Proposal A: Light “Rumble Strips” to alert drivers who cross over onto the shoulder. Rumble Strips sometimes can be a bit of a hazard to cyclists -- very rough spots in the road can cause an inexperienced cyclist to lose control. However, if the rumble strips could be made to be fairly light -- shallow grooves, cut 6 inches wide -- that would minimize the danger to cyclists. Overall, the improved safety to cyclists by alerting automobile drivers to their “drifting” across the solid white line onto the shoulder is far, far greater than the minor dangers created by the rumble strips themselves.

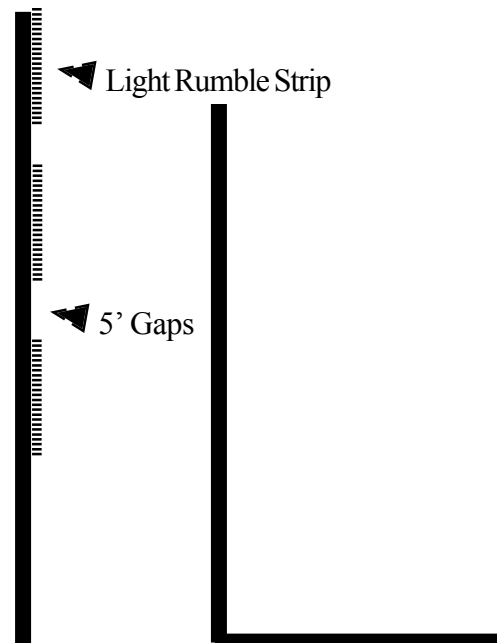
We would also recommend that 5’ gaps be created in the rumble strips at regular intervals. On rare occasions, a cyclist does need to enter the flow of traffic (usually because a stalled car or some other obstacle has blocked the shoulder). For those rare occasions, these gaps would provide a smooth and safe path off and back on the shoulder.

And of course, rumble strips should not be placed in close proximity to intersections.

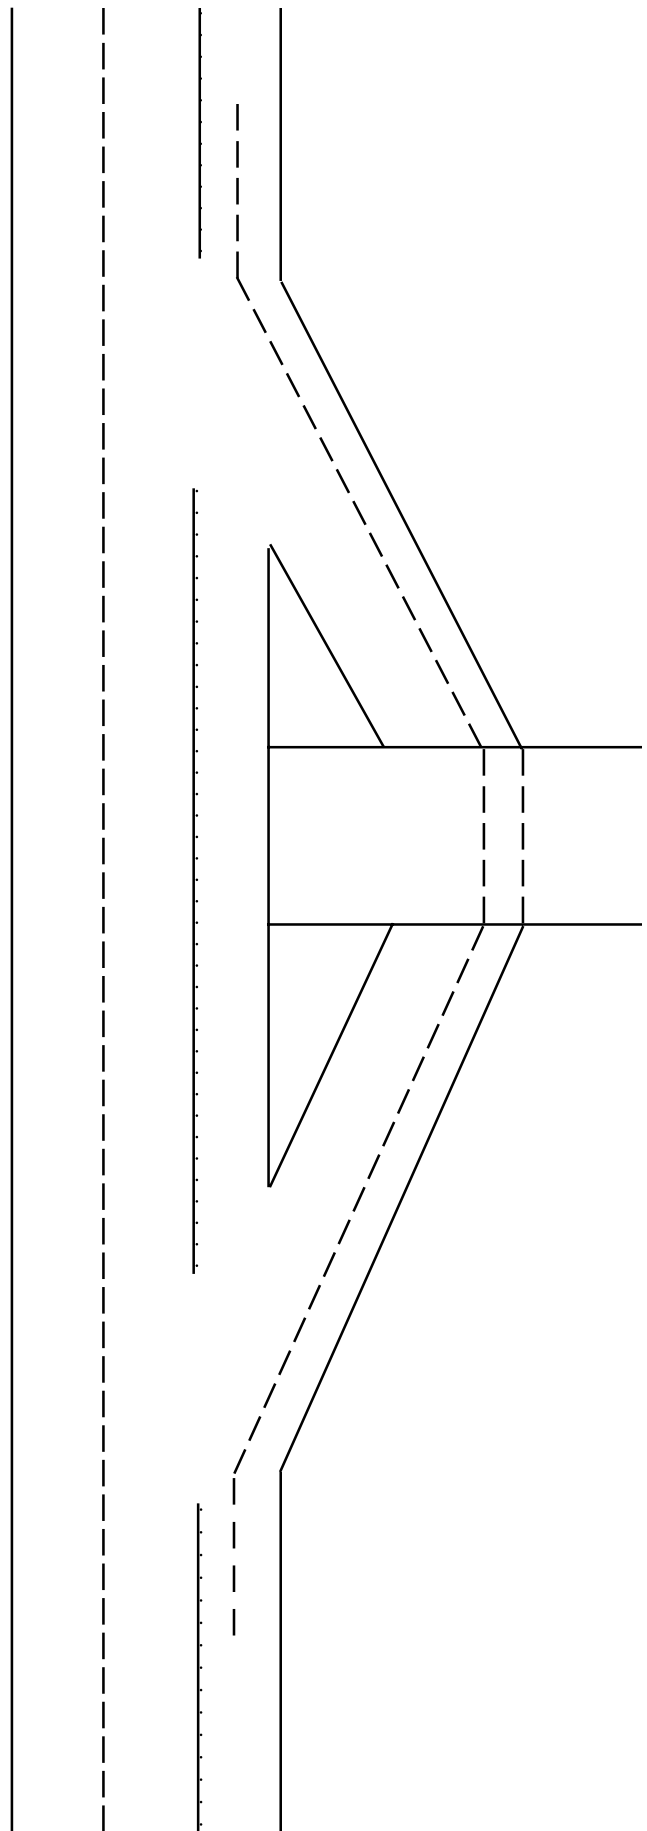
Proposal B: At the intersection of Loop 360 and Bee Cave Road (2244), and at the intersection of 360 and 2222, paint a recommended bike path encouraging cyclists to go down the exit ramp and then back up the entrance ramp. This would caution cyclists against the dangers of attempting to cross the exiting flow of automobile traffic.

What is depicted here is a dashed line that starts some distance before the exit, encouraging cyclists to move to the right of the shoulder, and travel down the exit ramp. What is not depicted here, although it is highly recommended, are painted graphics clearly indicating that this is a bike path.

The southbound entrance ramp from 2222 is somewhat more complicated than is depicted here, but the principle could still be applied.

Note: The rumble strips (Proposal A) are depicted here as well, with clear breaks where cars would be entering or exiting the flow of traffic.

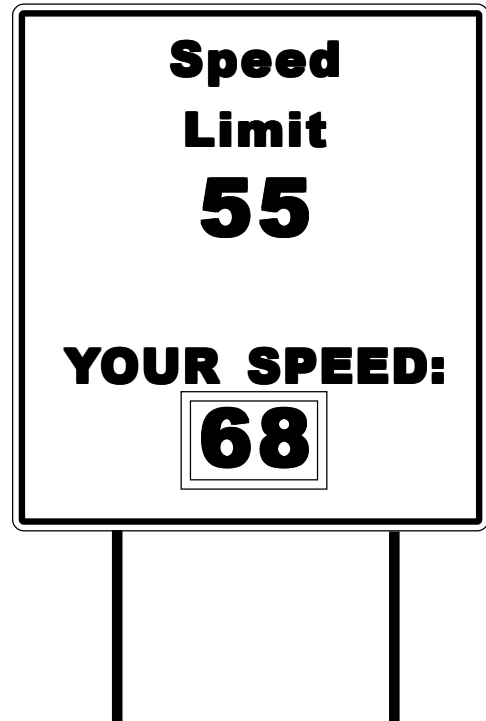
Proposal C: Improved Signage. Many people apparently believe that cyclists do not have a right to travel as lawful vehicles on Loop 360. A few well-placed signs can easily dispel that myth.

These signs should be large, and they should be placed near “hazard zones,” such as Bee Cave Road, 2222, and Mo-Pac.

Also, many motorists treat Loop 360 as though it was a limited-access expressway, instead of a high-volume highway with traffic lights and limited visibility. Better signage to control speeding would cut down on accidents.

We recommend the automated radar signs that remind people of the speed limit and provide feedback about their current speed. These signs have been shown in controlled studies to be highly effective for reducing traffic speed -- much more so than increasing the number or size of traditional speed-limit signs.
